**MOOG**  
STEERING & SUSPENSION

## DID YOU KNOW?

#### Overview

This bulletin will assist technicians servicing the 2003 through mid-year 2008 Dodge Ram 2500/3500 4x4 and 2006 through mid-year 2008 Dodge Ram 1500 Extended Cab 4x4 in identifying the correct steering linkage design before installing any new components. Technicians must closely examine the existing front-end components to determine if any 2009 and later parts (2nd design) have been previously installed.

Photo 1

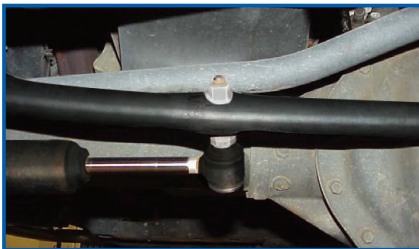
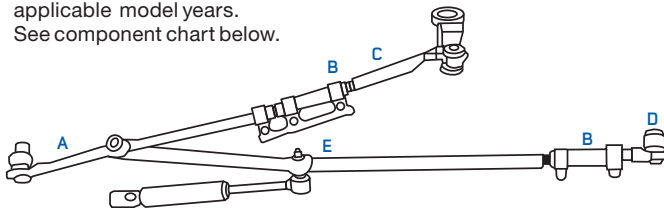
Examine the steering damper attachment point as follows:  
If the steering damper is bolted through a tapered hole in the RH inner connecting tie rod, as originally equipped (Photo 1), the parts have not been altered. It is acceptable to install parts designed for the applicable model years.  
See component chart below.

2003-2008 Dodge Ram 2500/3500 4x4, 2006 - mid-year 2008 Dodge Ram 1500 Extnd Cab 4x4 (1st design)			
PITMAN ARM TO RH STEERING ARM	A	RH OUTER TIE ROD END	DS1463
	B	ADJUSTING SLEEVE	ES3626S
	C	LH INNER TIE ROD AT PITMAN ARM	ES3624
LH STEERING ARM TO CONNECTING TIE ROD	D	LH OUTER TIE ROD	ES3625
	B	ADJUSTING SLEEVE	ES3626S
	E	RH INNER CONNECTING TIE ROD	DS1464
